March 23, 2001
NRC:01:014

Request for Additional Information – Framatome ANP Richland, Inc. Topical Report EMF-2361(P) Revision 0, EXEM BWR-2000 ECCS Evaluation Model, (TAC NO. MB0574)

**Request for Additional Information on Topical Report
EMF-2361(P) Revision 0, EXEM BWR-2000 ECCS Evaluation Model**

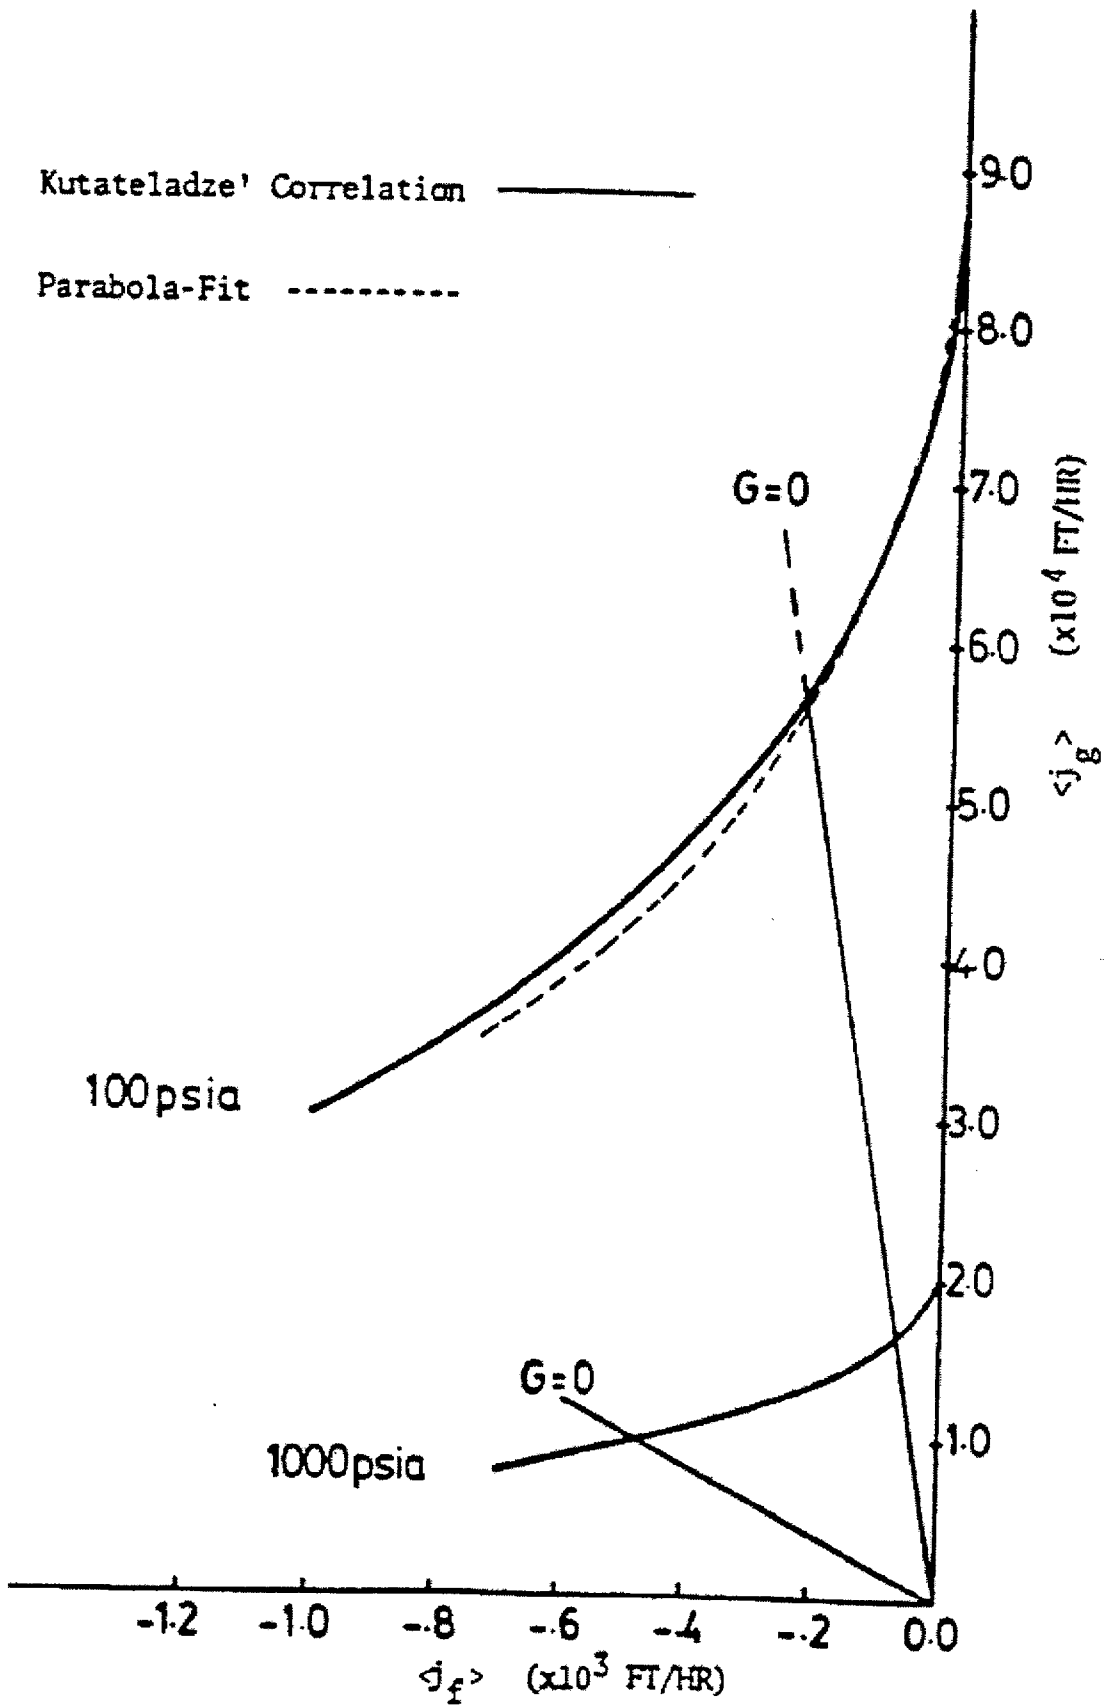
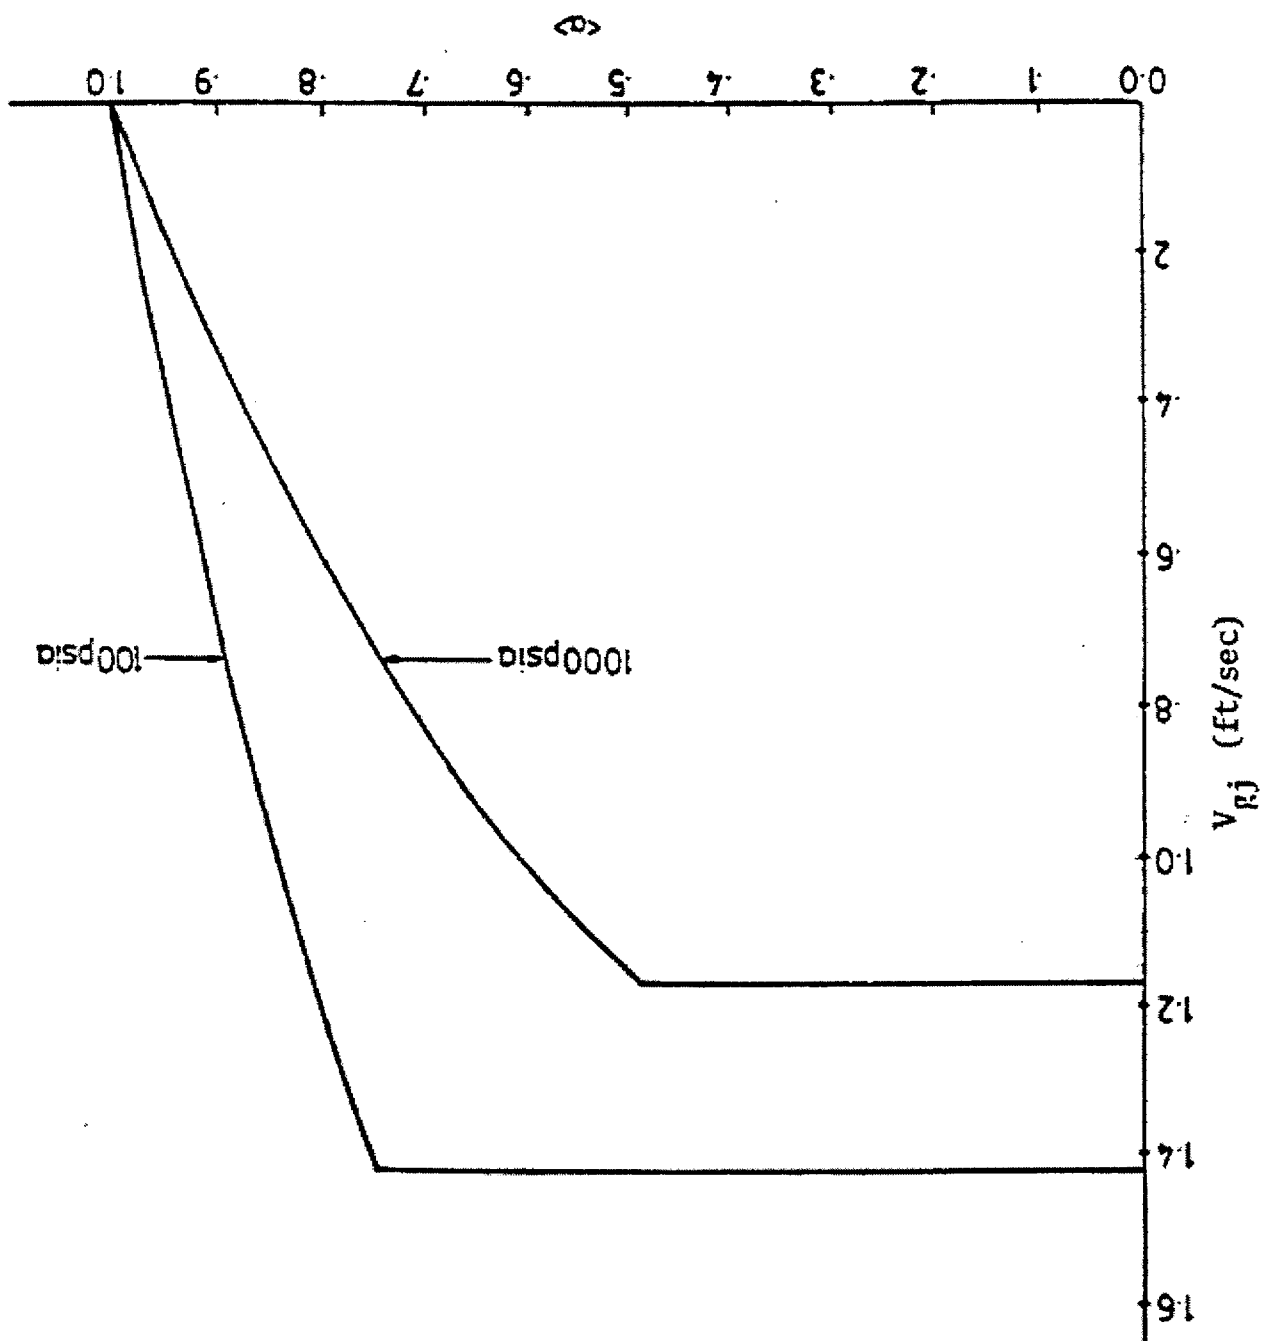
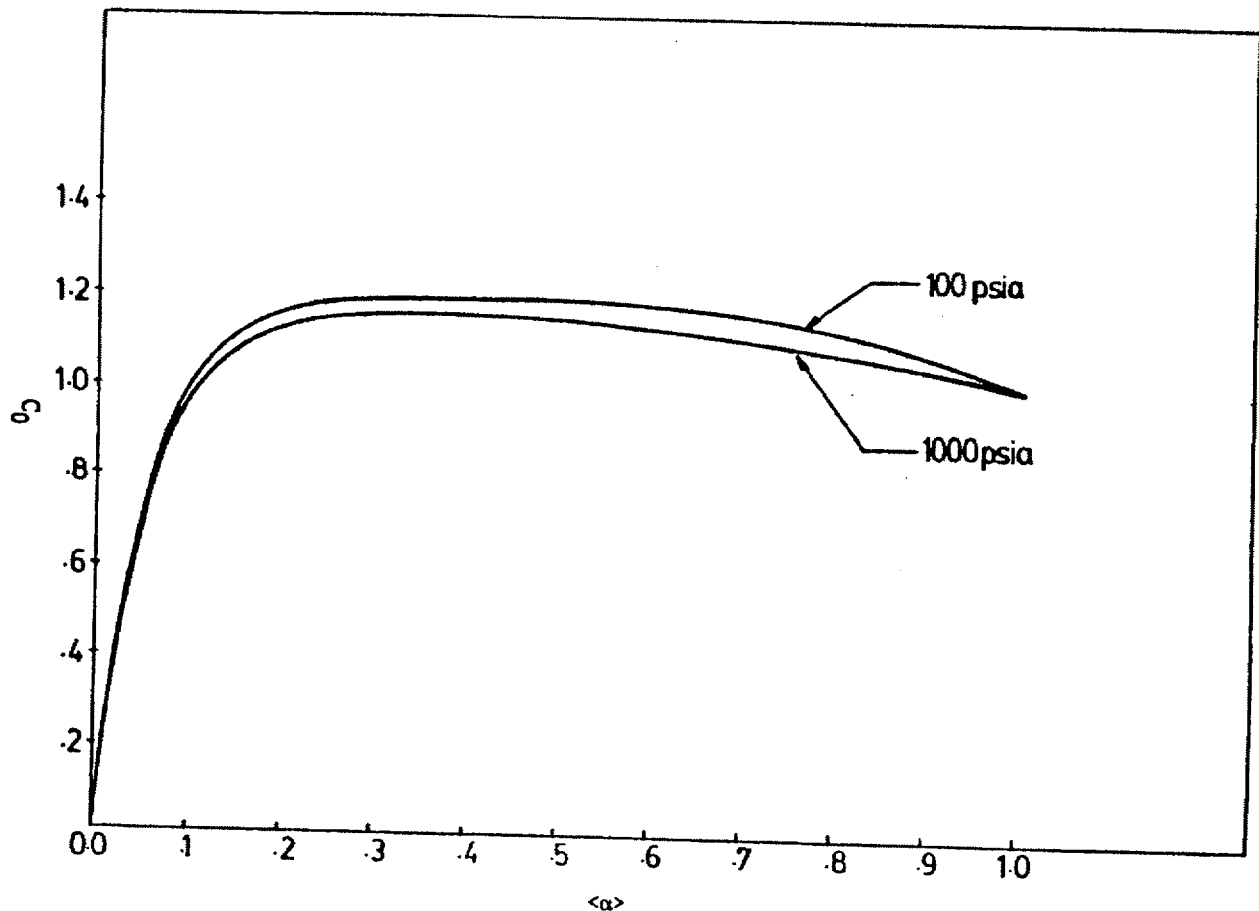
In Figure 3.1 of the report, the effect of drift flux models on void fraction was presented for steady state conditions. The staff requests the applicant to submit comparisons of void fraction distribution predicted by EXEM BWR-2000 with other approved code and test results at intermediate and low pressures also. The pressure should include values typically encountered during refill/reflood phase.

The document NES-486, "The Analysis of Proposed BWR Inlet Flow Blockage Experiments in PBF," describes the analytical development of the Ohkawa-Lahey drift flux model and shows that the drift flux model was designed to provide a smooth and continuous representation for a wide range of pressures (on the order of 100 to 2000 psia) and that it is applicable over the parametric space that is encountered in the RELAX calculations. The following figures from NES-486 show that the correlation is designed to provide a smooth representation of the drift flux from low to high pressure.

The first figure shows a parabolic fit to the data compared to the Ohkawa-Lahey drift flux model and its implementation in the Kutateladze form. This figure demonstrates that the Ohkawa-Lahey drift flux model adequately represents data taken at lower pressures. The second and third figures show the representations of void fraction versus slip velocity and C_o (where C_o is the parameter used in the Zuber-Findley drift flux formulation). These two figures show the behavior of the Ohkawa-Lahey drift flux correlation for both 100 and 1000 psia, for which it was designed. The calculation of C_o and slip velocity are well behaved and have no specific flow regime dependence; they are continuous and stable throughout the operating space to which they are applied.

The Appendix K features of the methodology and the transient conditions encountered during the event obscure the effects of the drift flux model for comparisons of the RELAX calculations against the large break FIST cases. The small break case provides a better basis to judge the adequacy of the drift flux model. The topical report, EMF-2361(P), contains a plot (Figure 5.46) that compares the calculated and measured bundle mass versus time (at low pressure) for the small break case and shows reasonable agreement.
